Access Compliance Report

Public Rights-of-Way

(Curb Ramps)

| Intersection ID: 50523 | Main Street: SHEFFINGDELL_DR | Cross Street: JASMIN_MAY_DR | Location: E |

| ADA ID: A0BC27D9FCC8 | Ramp Type: PerpDiag | Initial Pass/Fail: Fail | Overall Compliance: No |

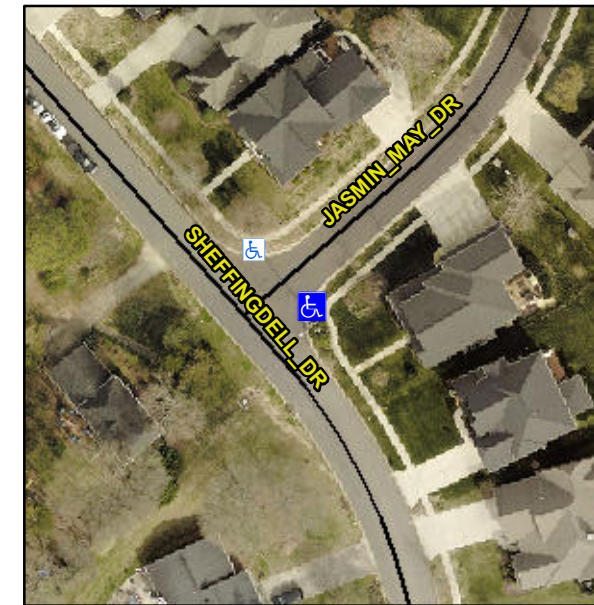
Not Found, R304.5.1

| Compliance | Description | Data | Compliance | Description | Data |
|------------|-----------------------|-------|------------|-----------------------------|-------|
| No | Ramp Width (in) | 47.0 | Yes | Ramp XSlope (%) | 0.7 |

Remove & Replace Curb Ramp With Two New Directional Ramps or Equivalent.
